Objections to Inclusion of Candidate Site

ID 370 Bryn Melin

In the Preferred Strategy for the VOG RLDP (Stage 2 Site Register)

Ref : brynmelindec23rev5

Fig 1 . Original site of 4.3 hectares for 130 houses

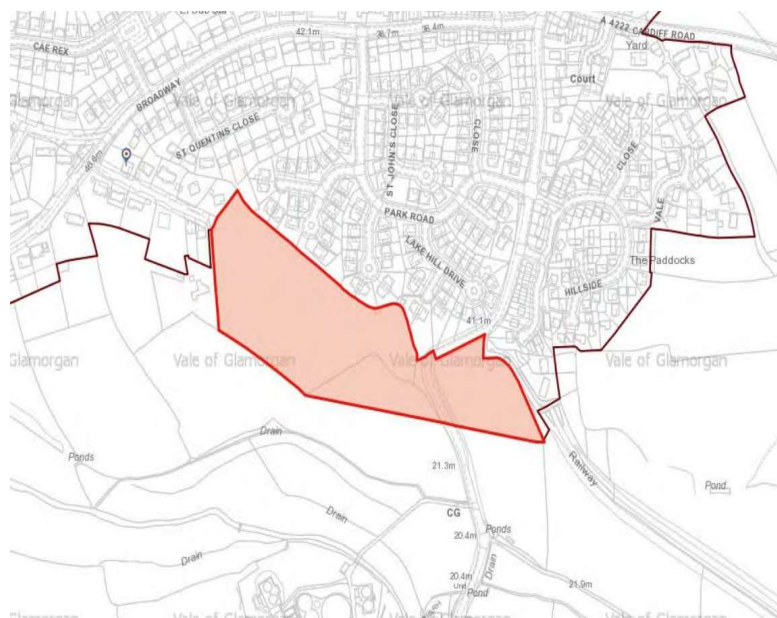
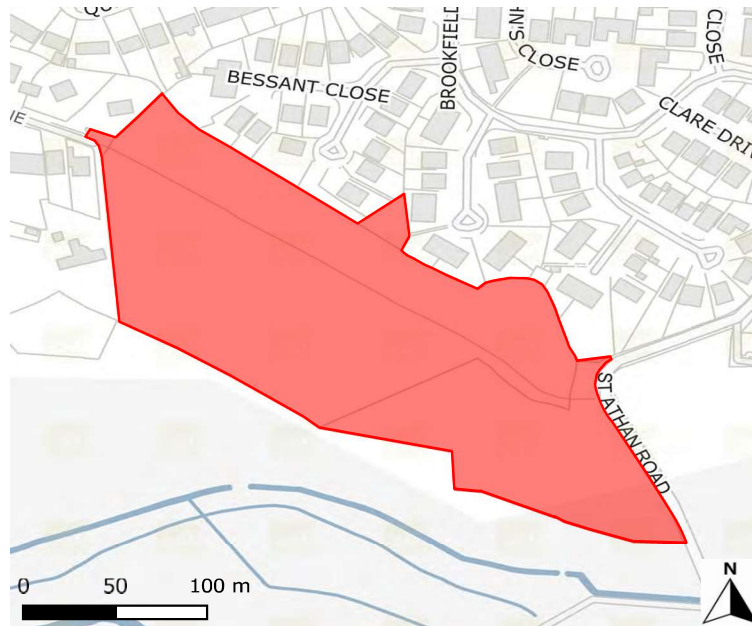
It is clear from the drawings above that the sites are different. The new site is supposed to be 3.8 Ha but additional land has been added to the original proposal whilst some land has been deleted. All of the land to the east of the St Athan Road has been removed and some additional land to the south of the site has been added for an attenuation basin together with a small triangle of land (existing green space on Brookfield Park estate not owned by the promotor/ developer) to the North. The resulting size of the new site is approximately 4.2 Ha. According to the guidelines this should have a density of 30 houses per hectare. i.e 126 house. Only 105 houses have been proposed.

Therefore the site should not pass stage 1 of the selection criteria

It is very unclear why the original site has changed from the original LDP approved site. The developer in submissions to the council claimed that they could not purchase the parcel of land to the east of the road which was fundamental to the candidate site as without it the road could not be realigned. It is not clear how the candidate site passed the viability and feasibility study in the original LDP if the developer / promoter did not own this piece of land. It is also unclear why the council allowed the developer to go ahead with plans for just part of the candidate site. The council insisted in written correspondence to the developer that any plans for the reduced site must not prevent the development of the other part of the site but now the other side of the road which was proposed as a candidate site for the RLDP has been rejected but the Bryn Melin site now minus the land needed to realign the St Athan Rd(as stipulated in the LDP) has been accepted.

Fig 2 Zone of theoretical Visibility

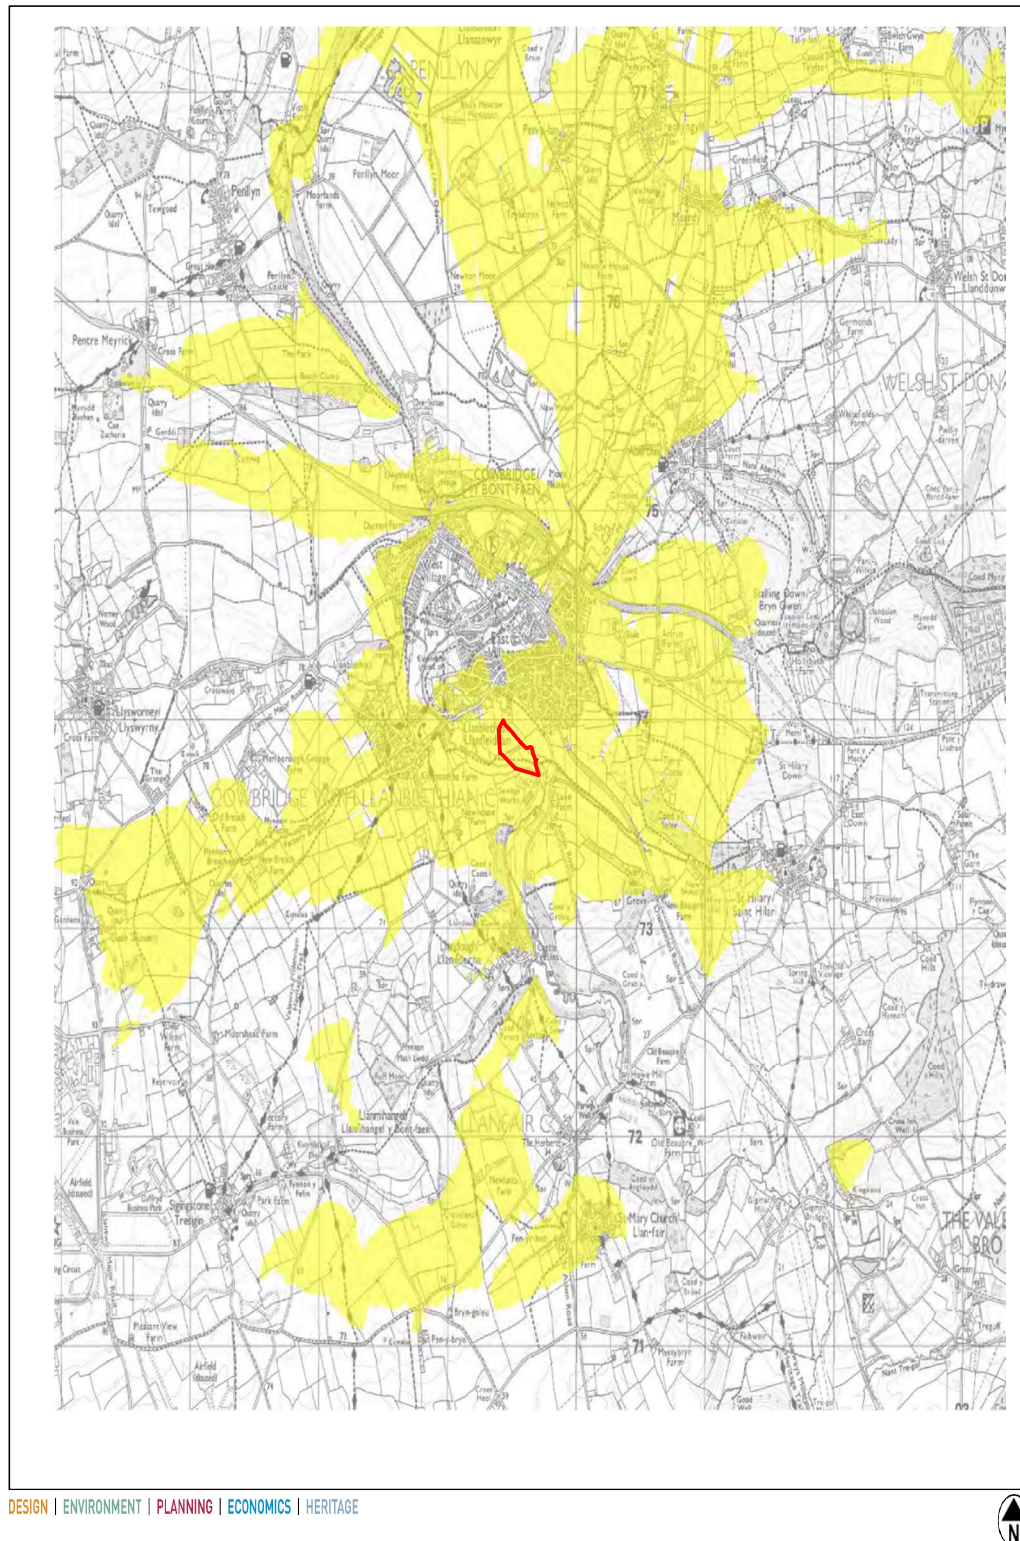
The site is very visible from a number of areas as identified by a map of the zone of theoretical visibility as shown below

Photo 3. Approach on the St Athan road from the South

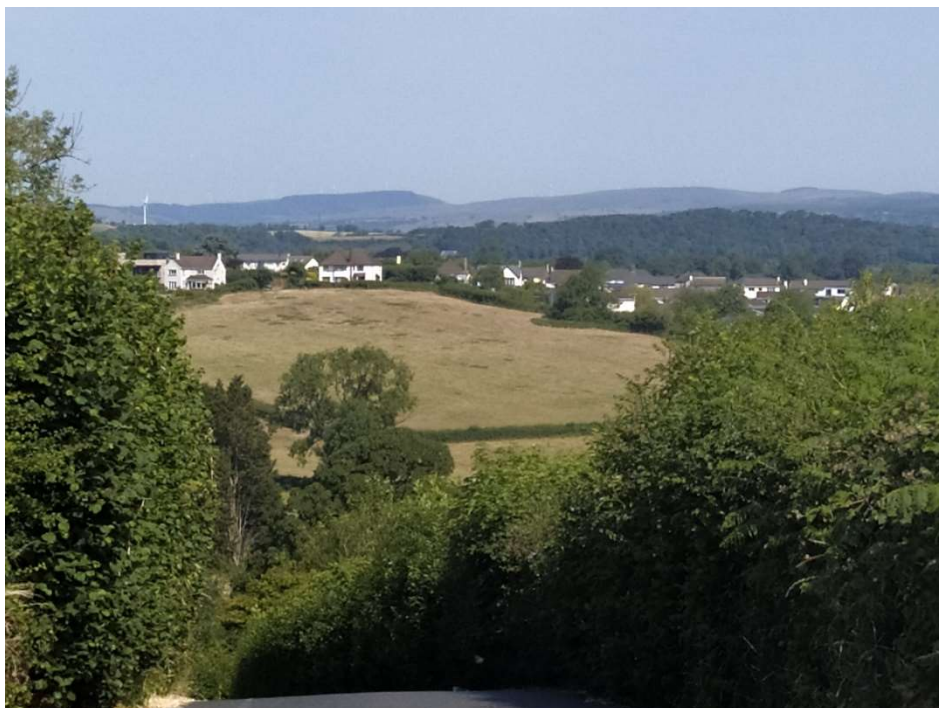
The photos 3 and 4 show how prominent the development will appear. It also shows how the Brookfield Park development is screened and sits down relatively obscured in the landscape.

Photo 7. Landmap for Wales showing half of the land is grade 3a

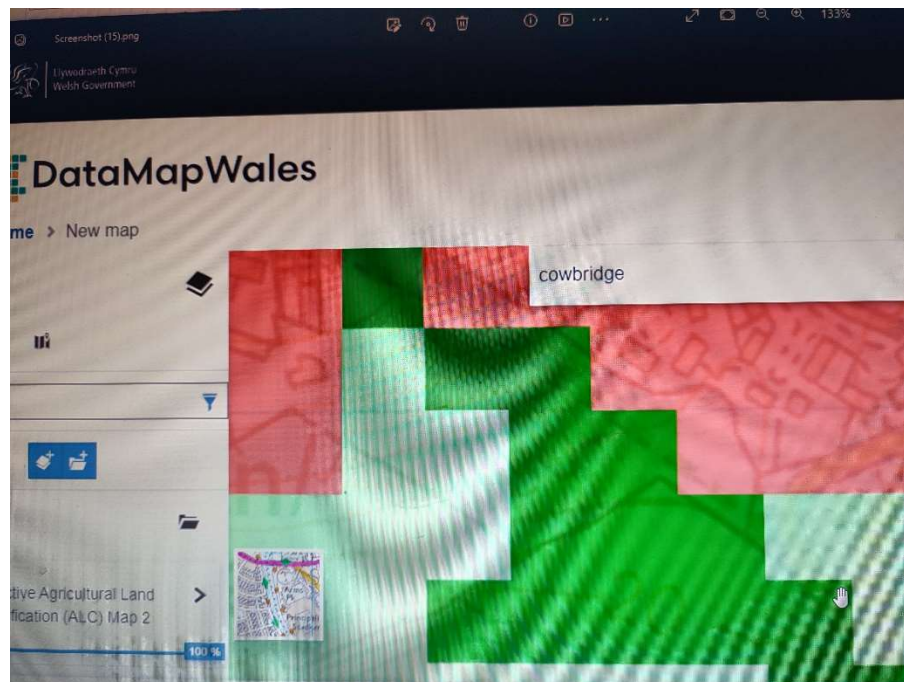
We have changed 11 ALC to red for the Bryn Melin site as it contains at least grade 3a land and is similar to site ID 367.

An ALC survey (VOG agricultural land assessment 2015) stated that the land was grade 2 (western third) and 3 which is considered valuable land. The recent landmap survey below shows the site to be 3a and 3b land/ The land to the north of the site is shown in dark green (3a) and the south of the site(pale green) 3b

2.1.4

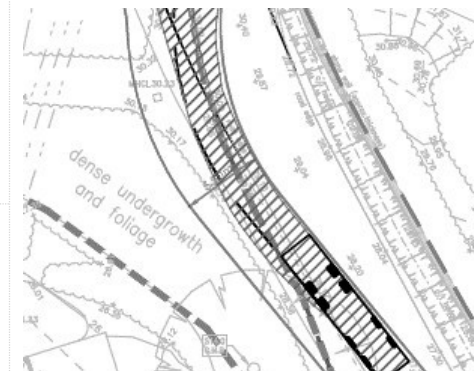
Summary Swept-path analysis of a large (refuse) vehicle shows the body of the vehicle over-sweeping the centreline of St Athan Road, at a point where the realigned carriageway reverts to the existing alignment and encroaches into the opposing lane. This could lead to head on or side-swipe type collisions, or for drivers to take avoiding action.

Location Approximately 30m south of the proposed access on to St Athan Road

It is noted from the plans provided that the body of the vehicle over-sweeping the centreline of St Athan Road, at a point where the realigned carriageway reverts to the existing alignment and encroaches into the opposing lane. This increases the potential for head-on or side-swipe type collisions, or for drivers to take avoiding action, increasing the potential for vehicles to mount the pavement [which is not shown on the swept-path diagram, but included on the site layout plan) and conflict with pedestrians.

It is recommended that the layout of the interface between the new and existing carriageway is re-designed to ensure large vehicles do not encroach into the opposing lane.

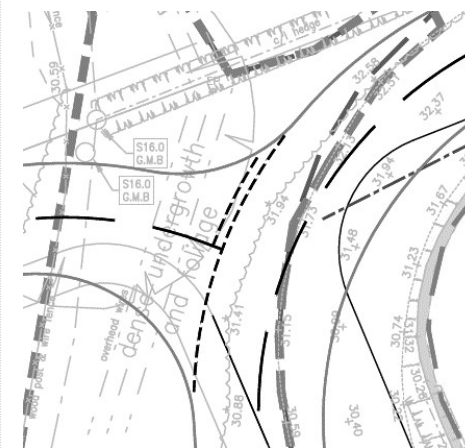
2.2.1 **Summary** It is unclear from the plans provided whether there is sufficient space for a large vehicle, travelling northbound along St Athan Road, to pass another vehicle waiting to turn right into the proposed development. Insufficient width could lead to side-swipe type collisions.

Location Realigned St Athan Road at the proposed junction on to Roman Road

In the absence of any specific details, it is difficult to determine whether there is sufficient width to accommodate a large vehicle (travelling northbound along St Athan Road) passing another vehicle (possibly large vehicle) waiting to turn right into the proposed development from St Athan Road. Insufficient width increases the potential for side-swipe type collisions.

It is recommended that additional swept-path analysis of the range of vehicles using St Athan Road and likely to use the new access is undertaken to determine whether there is sufficient room, and that the junction/access is amended accordingly.

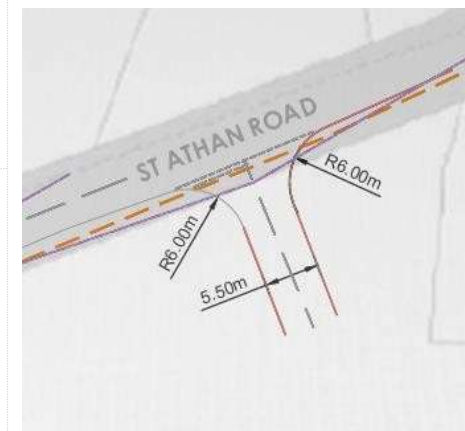
2.2.2 **Summary** The width of St Athan Road at the potential access measures approximately 4.5m wide, which is insufficient for a large vehicle, travelling southbound along St Athan Road, to pass another vehicle waiting to turn right into the proposed development. Insufficient width could lead to side-swipe type collisions.

Location Potential access to land to the south and east of St Athan Road

It was noted from the site visit that St Athan Road, at the potential access, measures approximately 4.5m wide. This is insufficient for a large vehicle, travelling southbound along St Athan Road, to pass another vehicle waiting to turn right into the proposed development. Insufficient width could lead to side-swipe type collisions.

It is recommended that the width of St Athan Road at this location is widened to a minimum of 5.5m, to allow large vehicles to pass other vehicles waiting to turn right into the site.

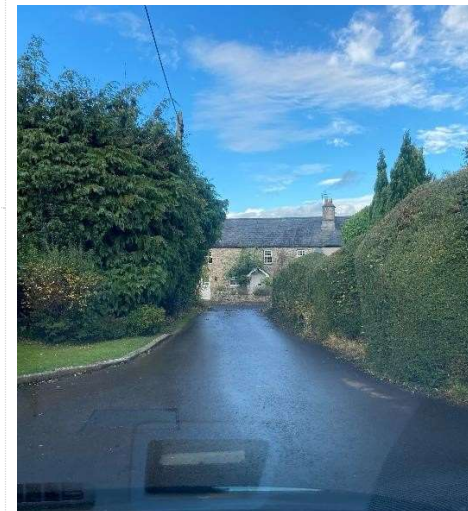
2.3.3 Summary The proposed pedestrian/cycle link to the site from Windmill Lane is of substandard width, particularly on the approach to Broadway, where there is insufficient width for a car to pass a pedestrian, particularly a pedestrian with a pushchair or those using a wheelchair, increasing the potential for pedestrians to be hit by passing vehicles.

Location Windmill Lane, on the approach to Broadway.

It is noted from the plans provided that it is proposed to provide a pedestrian and cycle access to the site from Windmill Lane, which is a shared-surface road serving approximately 12 dwellings. However, it was noted from the site visit that the width of Windmill Lane reduces on the approach to Broadway and there is insufficient width for a car to pass a pedestrian (particularly a pedestrian with a pushchair or those using a wheelchair) or a cyclist. This increases the potential for pedestrians to be hit by passing vehicles. This is exacerbated by the limited visibility from Broadway (w) to Windmill Lane.

It is recommended that a more suitable pedestrian/cycle access to the site is provided, that removes the conflict between pedestrians and cyclists.
